## **Assessment of the Operating and Post-Closure Stability of the Open Pit at the Proposed Ioneer Rhyolite Ridge Lithium-Boron Mine, Esmeralda County, Southwestern Nevada**

Steven H. Emerman, Malach Consulting, 785 N 200 W, Spanish Fork, Utah 84660, USA, Email: SHEmerman@gmail.com, Tel: 1-801-921-1228

Report prepared at the request of the Center for Biological Diversity  
Submitted May 29, 2024

**Figure 14.** Geo-Logic Associates (2023) updated the design of Sections TR02E-05, TR02E-6, TR02E-7, TR02E-8, TR02E-9, and TR02E-11 with a goal of increasing the factor of safety (see Fig. 15). Figure from Geo-Logic Associates (2022) with overlay of larger labels for ease of reading.

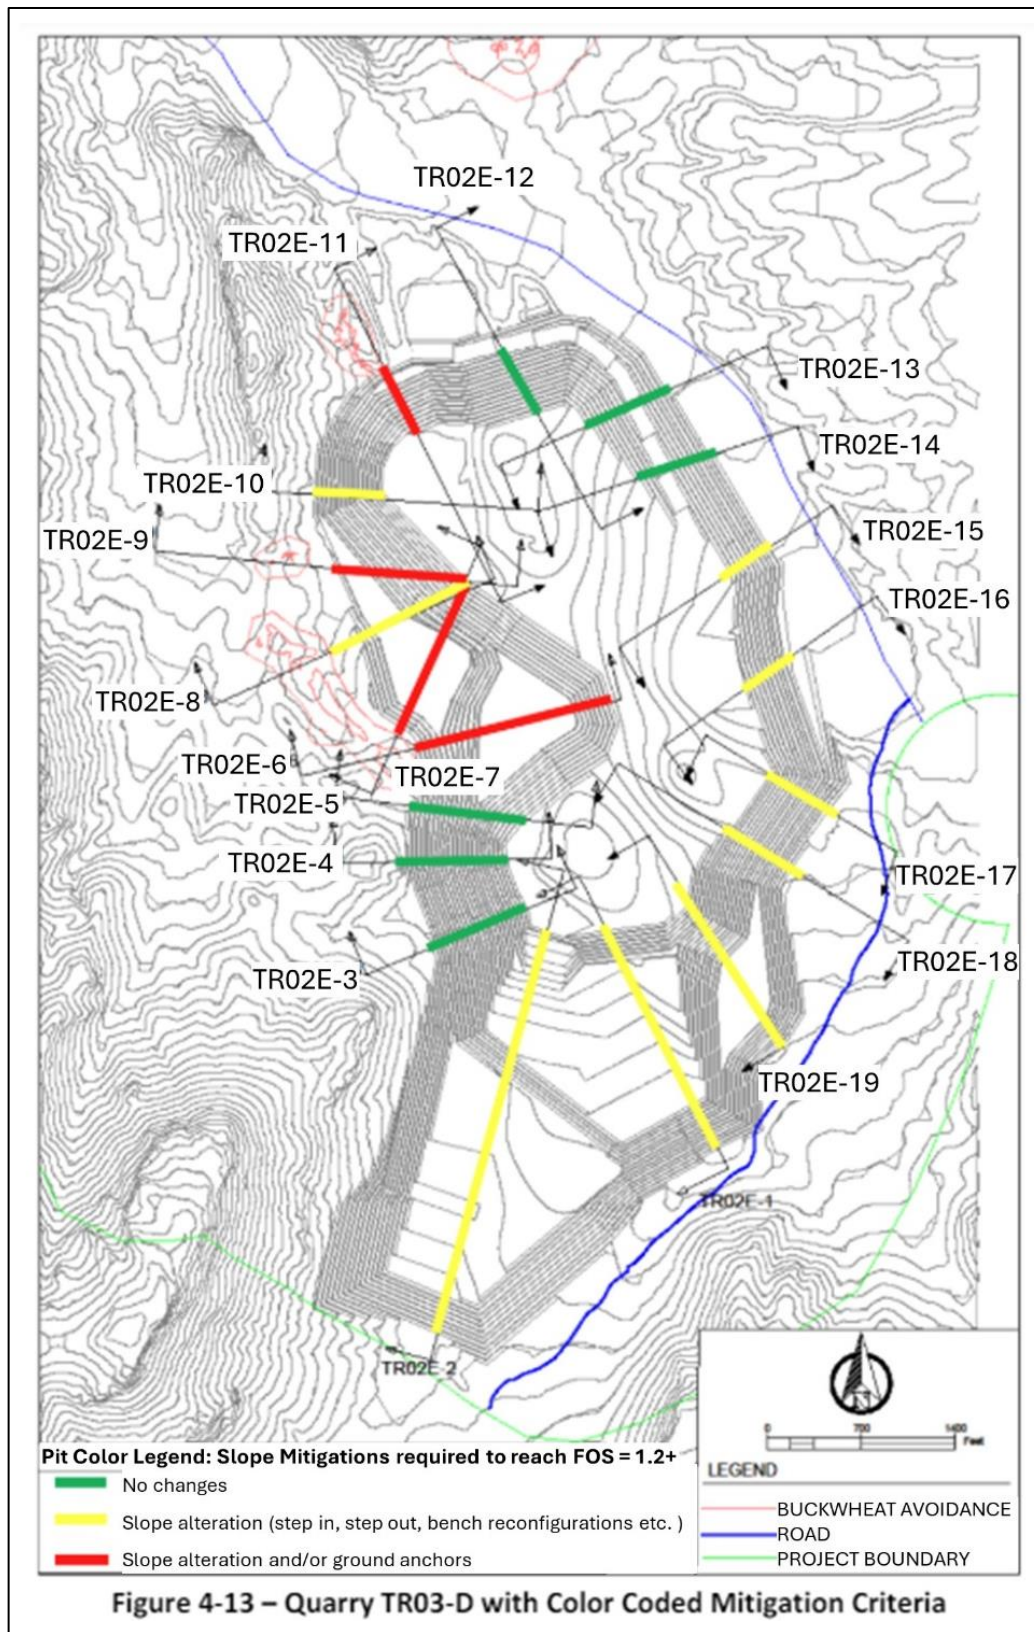
**Figure 15.** Without a buttress, the factors of safety for Sections TR02E-5, TR02E-6, TR02E-7, TR02E-8, TR02E-9, and TR02E-11 (see Fig. 14) range from 1.20 to 1.26. The stability analyses for the sections without an added buttress correspond to the operating period of the quarry, since a buttress is constructed as a part of pit closure. Thus, even without a buttress, the factors of safety fulfill the minimum factor of safety of 1.2 that was set by Geo-Logic Associates (2022, 2023), but not the minimum factor of safety of 1.3-1.5 that is recommended by the Guidelines for Open Pit Slope Design and the SME Surface Mining Handbook. The upper range of 1.5 would be preferred for the Rhyolite Ridge mine due to the high degree of uncertainty in the geotechnical data (see Fig. 19). The addition of buttresses for pit closure (Condition 1) increases the factors of safety to the range 1.25-1.57. This again fulfills the minimum factor of safety of 1.2 that was set by Geo-Logic Associates (2022, 2023), but not the minimum factor of safety of 2.0 that would be recommended by the Guidelines for Mine Closure (see Fig. 26a-c) for the pit wall condition, failure consequences, and design confidence of the quarry at the Rhyolite Ridge mine. The right-hand column (Condition 3) states the factor of safety for a surface that is not the critical failure surface, so that its significance is not apparent. Figure from Geo-Logic Associates (2023).

There are multiple grounds for concluding that the calculations of the factor of safety by Geo-Logic Associates (2022, 2023; see Fig. 15) are unreliable. Whether the minimum factor of safety of 1.2 was the correct choice is a different matter, which is discussed in the following two subsections. The geotechnical parameters for each geologic unit that were the input data for the calculation of the factor of safety are stated with ultra-precision, sometimes with as many as five significant digits (see Fig. 13). Geo-Logic Associates (2022, 2023) does not provide any information on the uncertainty in the input data that would justify such a high degree of precision. As mentioned earlier, the DEIS does not identify any source of construction material for the buttress, so the material properties of the buttress must be regarded as purely hypothetical (see Fig. 13).

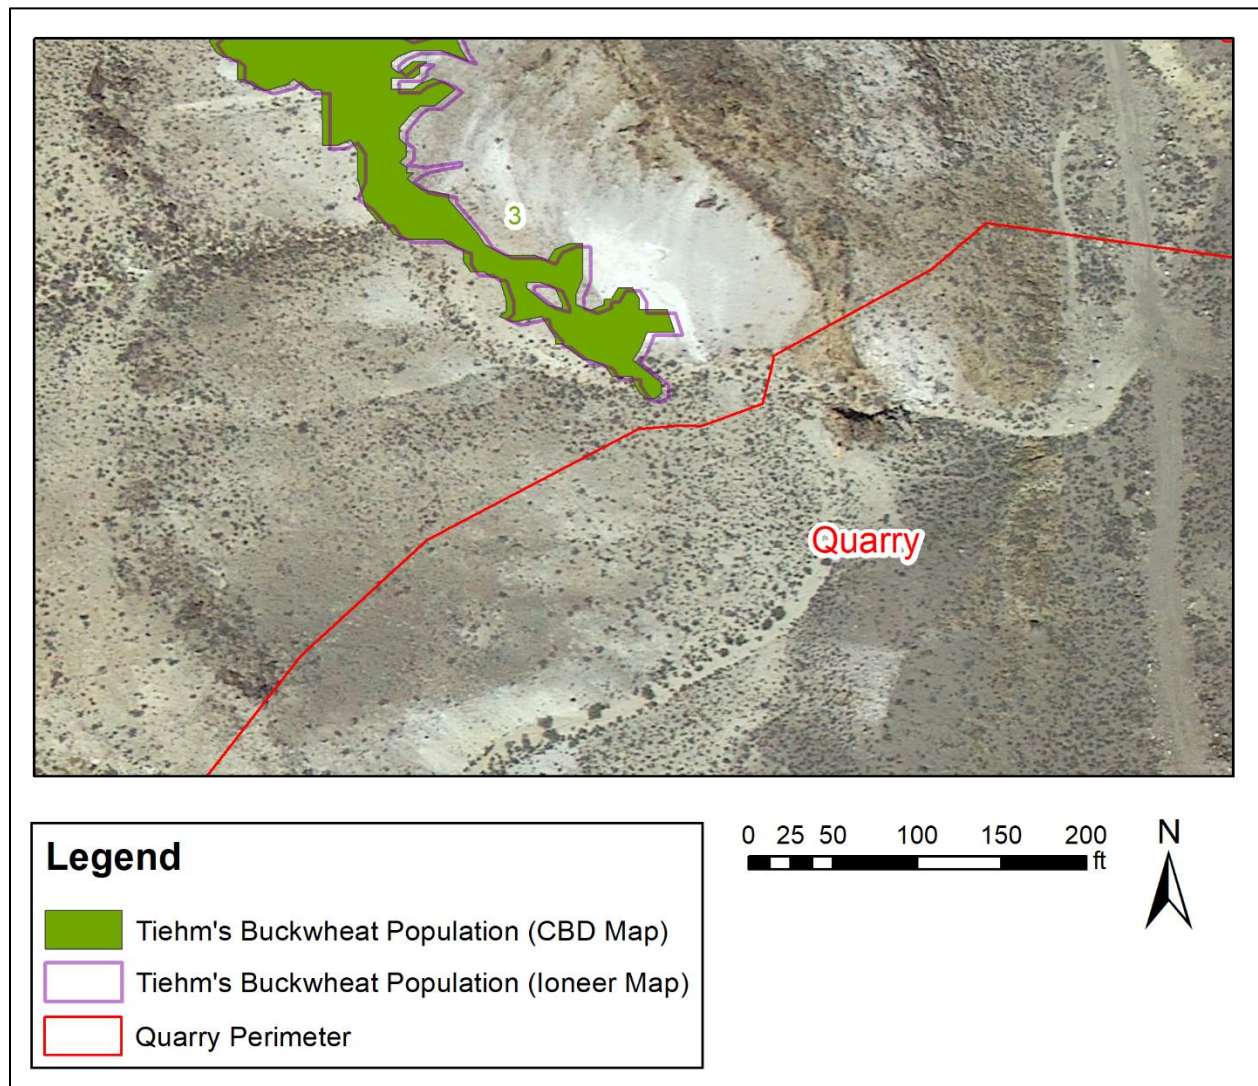
Before addressing the methodology for answering the preceding questions, it is appropriate to return to the issues raised in the "Overview" section that some information in the DEIS is inconsistent with information in other sources and that some information in the DEIS has already been acknowledged by the Bureau of Land Management to be out-of-date. The maps of the Tiehm's buckwheat populations prepared by Ioneer for the DEIS and in use by the Center for Biological Diversity are compared in Figs. 16a-b. On the northern side of the quarry, the Ioneer version of the population is shifted toward the east and the south, although not in a consistent manner (see Fig. 16a). On the western side of the quarry, the Ioneer version of the population appears more generalized and may show additional subpopulations or clusters to the northeast of subpopulation 5, to the west of subpopulation 4, and to the southwest of subpopulation 6A (see Fig. 16b).

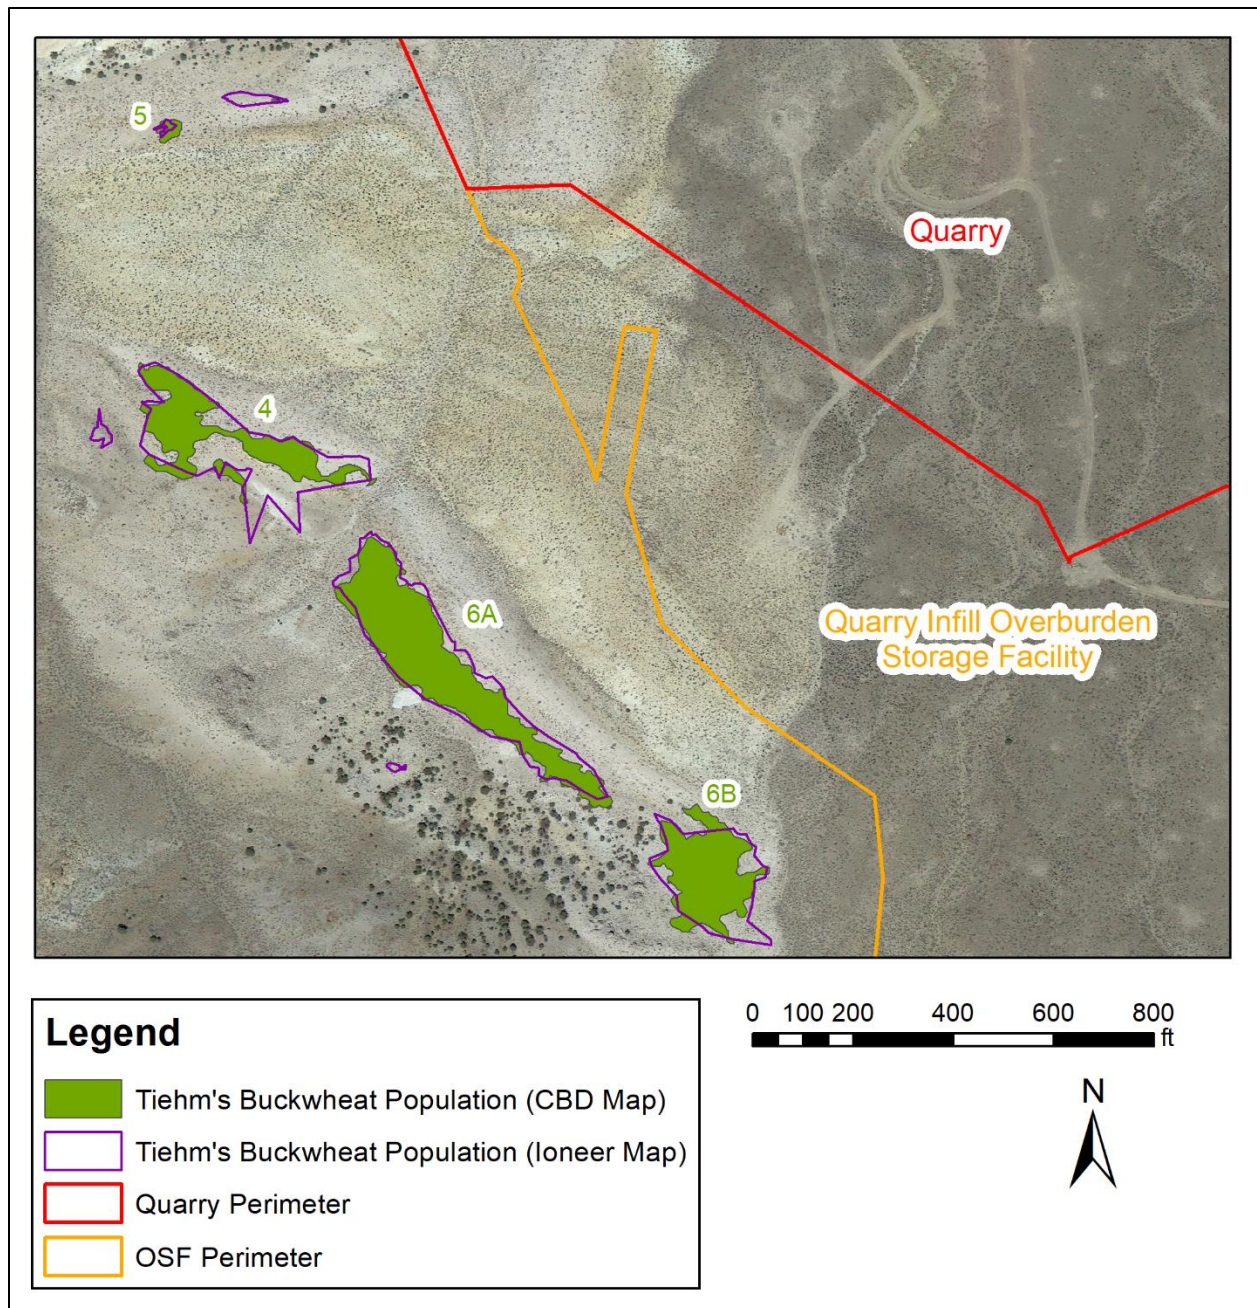
The correct location of the quarry is of critical importance, since that is the basis for the slope stability analyses. Without a correct location for the quarry, due to the very complex geology of faulted and folded geologic units, there is no way of knowing which geologic units will be intersected by the quarry walls, at what depths the units will be intersected, and what will be the inclinations (dips) of the units at those depths. Shapefiles for both the quarry perimeter and the haul roads were provided to the Center for Biological Diversity by the Bureau of Land Management. The quarry perimeter shows an indentation that would exactly accommodate the planned haul road (compare Figs. 17a-b). With regard to the haul road shapefile that was provided, the Bureau of Land Management (2024c) wrote, "The haul road location is currently being adjusted by Ioneer based on the consultation process between the BLM and the U.S. Fish & Wildlife Service. As such, the current shapefiles for the haul road location would provide no valuable information." Thus, if the haul road map (see Fig. 17b) does not show the haul road that would actually be constructed, then the quarry map (see Fig. 17a) is not the quarry that would actually be constructed, although the quarry map was the basis for the stability analyses in Geo-Logic Associates (2022, 2023). In the absence of any other workable procedure, the stability analyses contained in Geo-Logic Associates (2022, 2023) were evaluated in this report, even

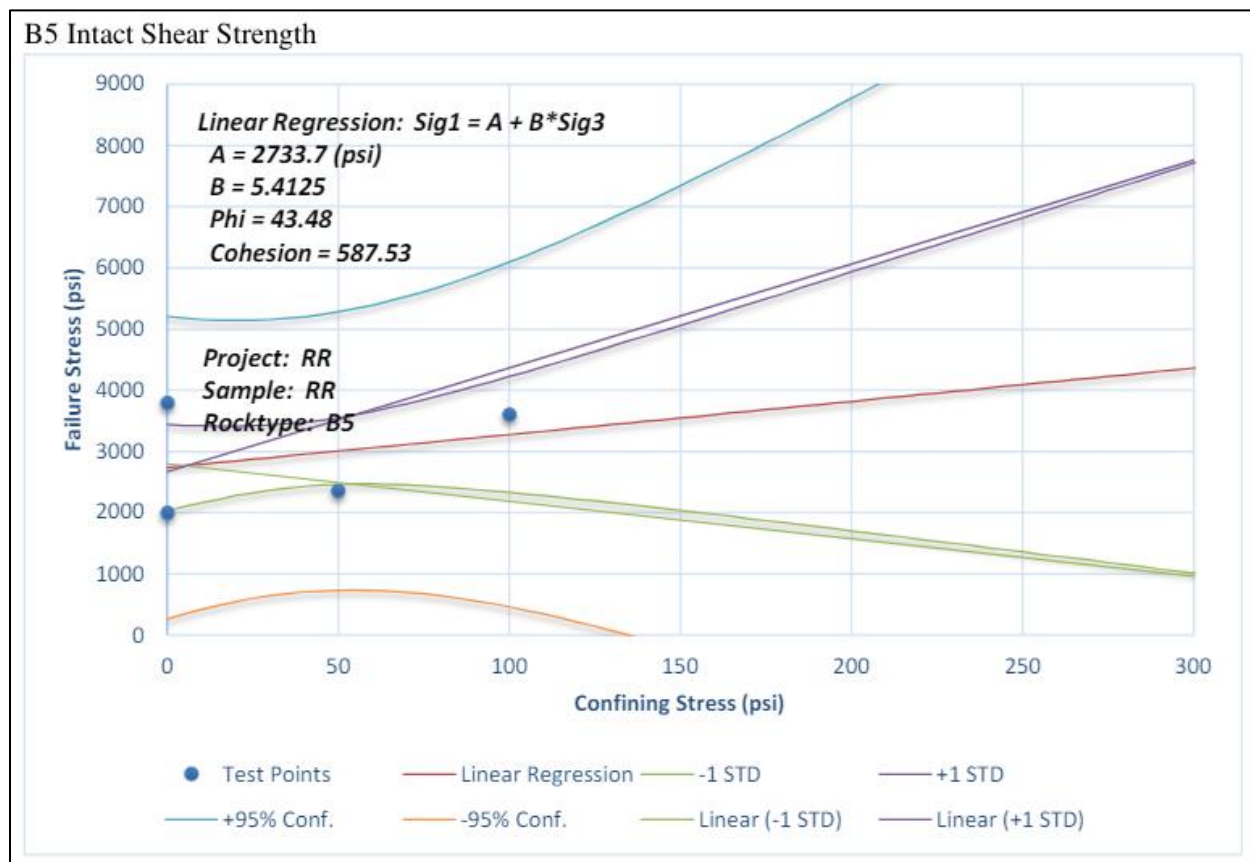
Geo-Logic Associates (2022) does present a portion of the raw geotechnical data that were used by EnviroMine (2019) to develop the material properties (see Fig. 13). These raw data do not provide confidence in the lack of uncertainty and ultra-precision that is shown in the list of material properties (see Fig. 13). Many of the raw data involve only three or four measurements on a single rock sample. For example, Fig. 19 shows four measurements of the failure stress as a function of the confining stress on a sample from Unit B5. The four measurements are widely scattered and do not in any way appear to fall along a straight line (see Fig. 19). Of course, it is always possible to construct a best-fit straight line to any four points and to state the slope and intercept of the line to five significant digits, as was done in Fig. 19. However, for this rock sample, the correct procedure would have been to observe that the failure stress was independent of the confining stress, to compute the intercept by averaging the four values of failure stress, and to set the slope of the line at zero. Such a procedure would have been more consistent with the “engineering judgment” that was claimed by Geo-Logic Associates (2022) to have been used by EnviroMine (2019).

are actually known to five significant digits and that there are no reasonable alternative values is simply absurd, especially in light of the large scatter in the raw geotechnical data (see Fig. 19).

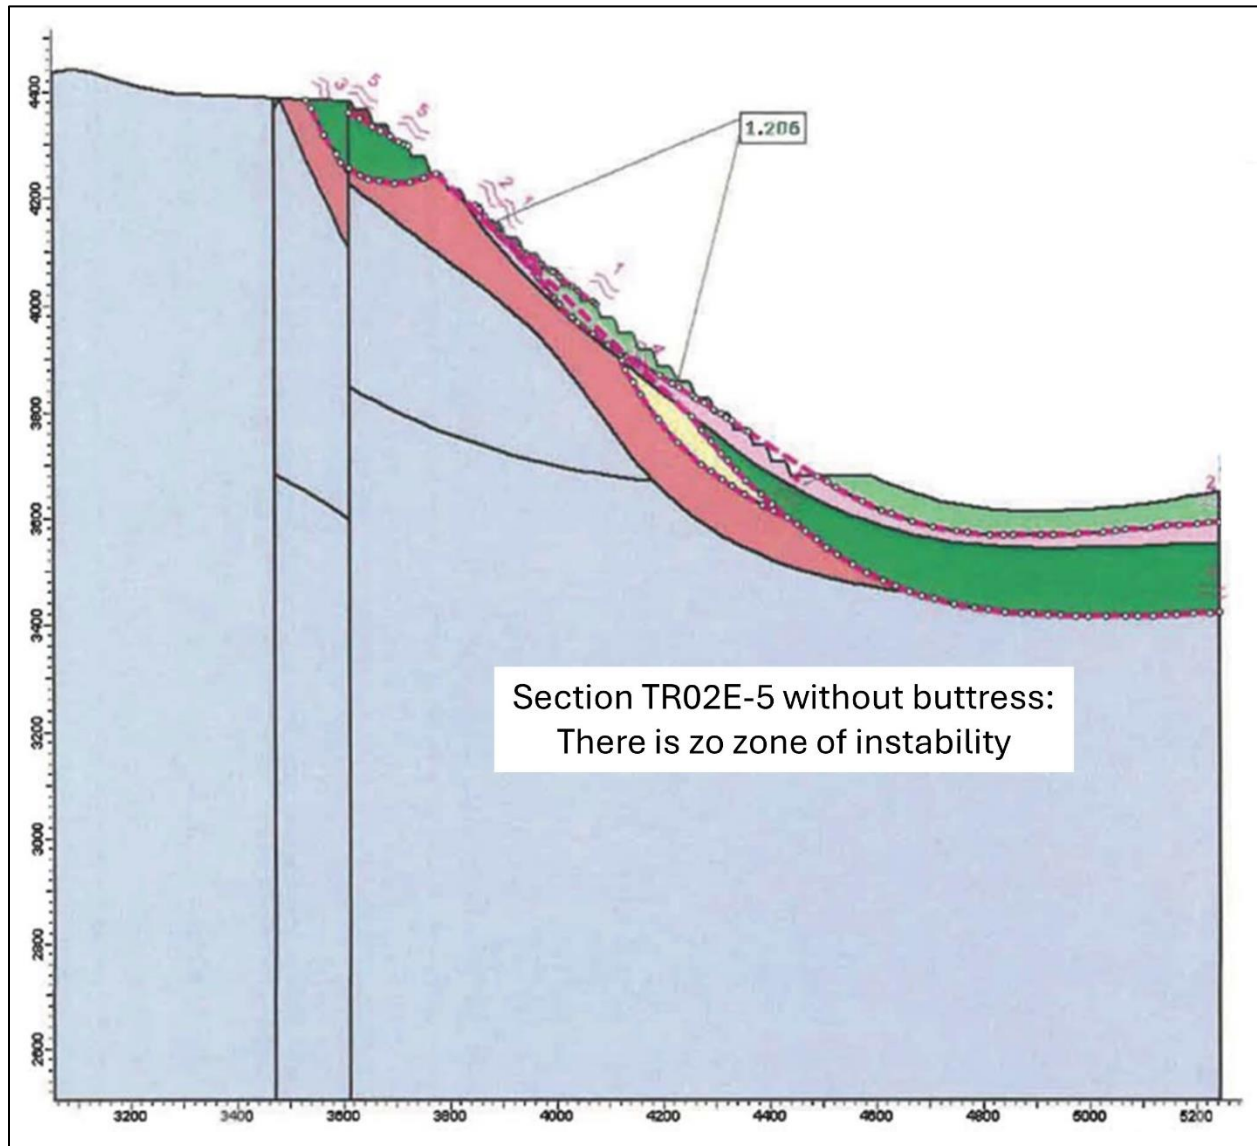
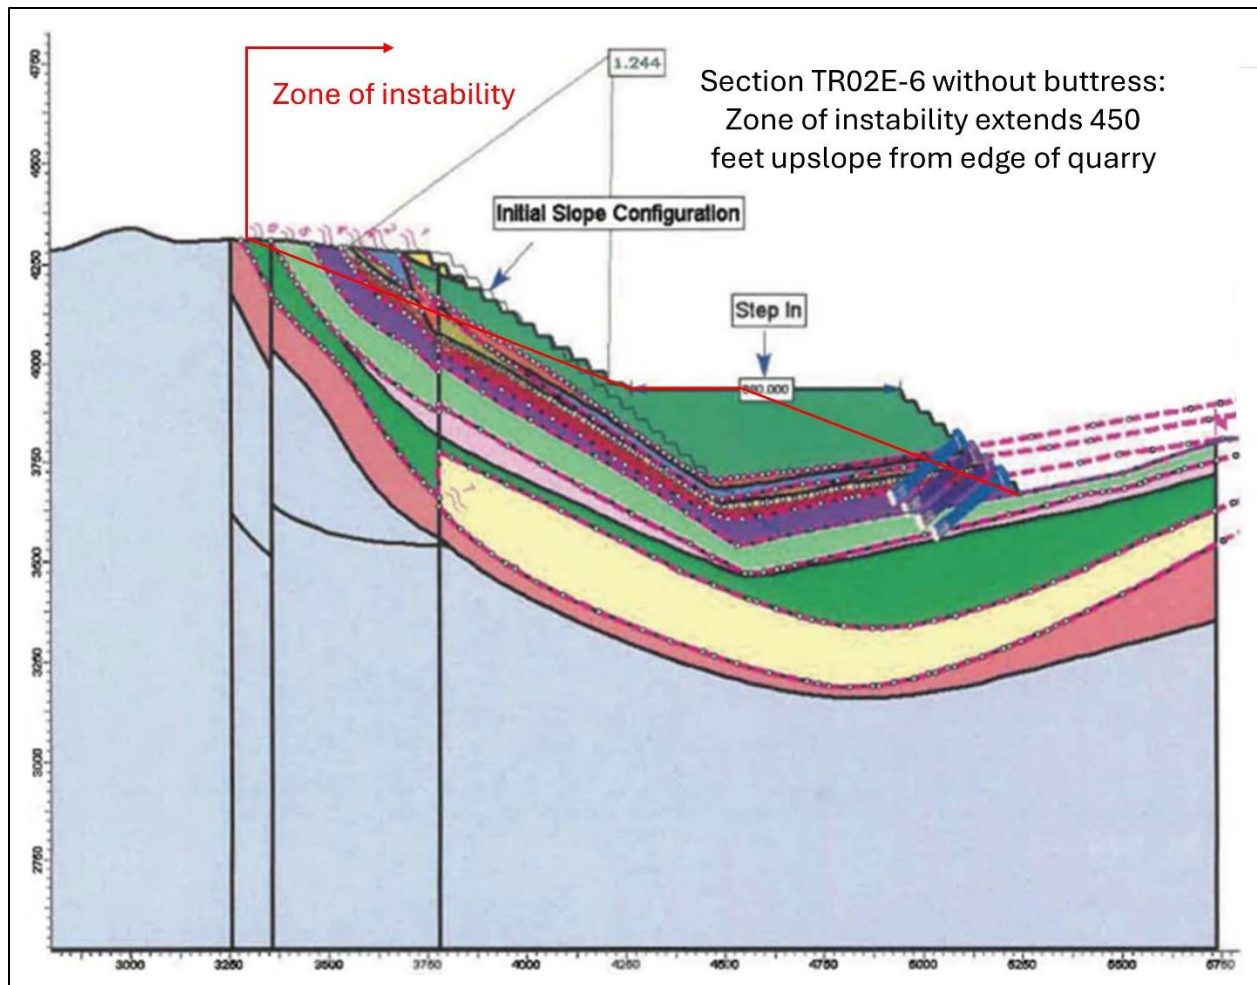
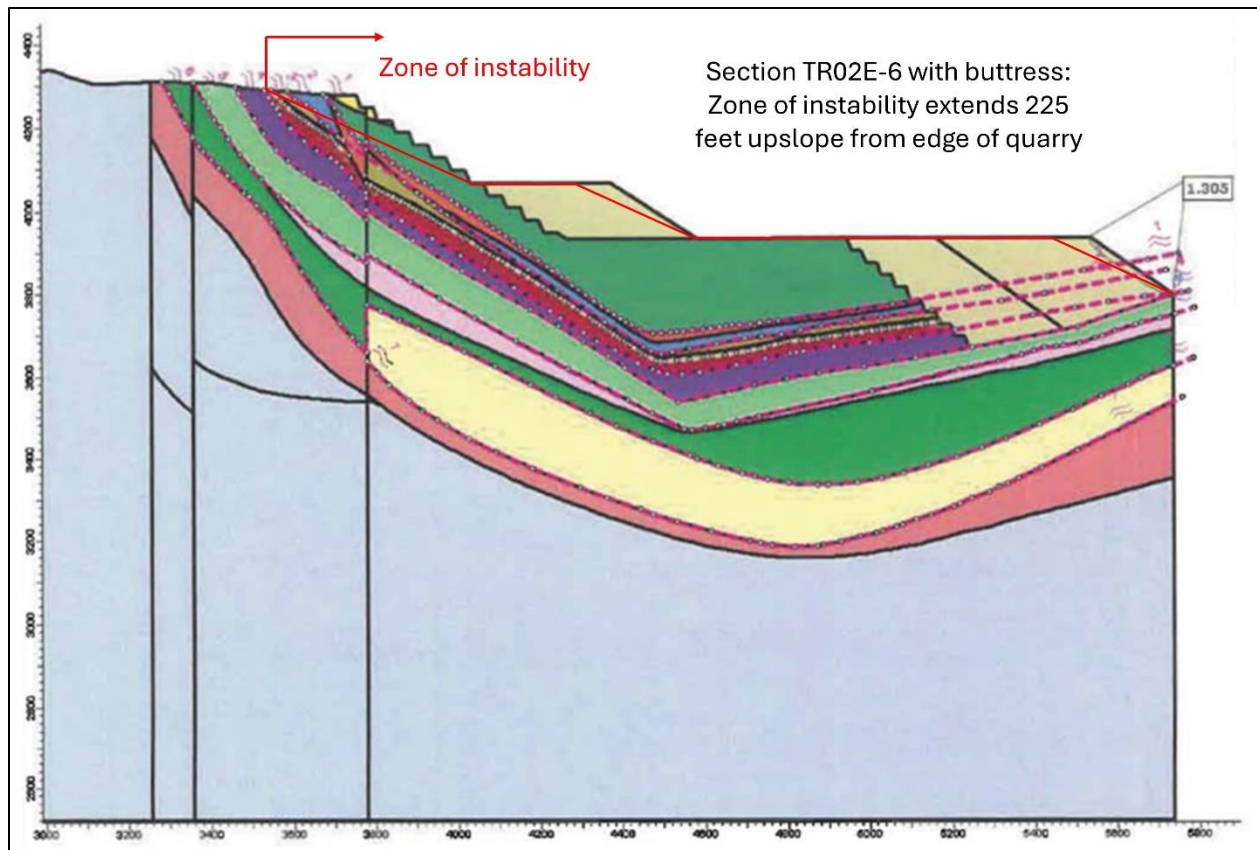
especially if it did not shift in an inward direction after construction of a buttress, then any predictions regarding the elimination of an unstable zone should be viewed with great caution.

- 17) Unless it can be convincingly argued to the contrary, the quarry should be designed so that the Tiehm's buckwheat population is at least 50 feet beyond the Zone of Instability, as specified in Western Australian regulations.
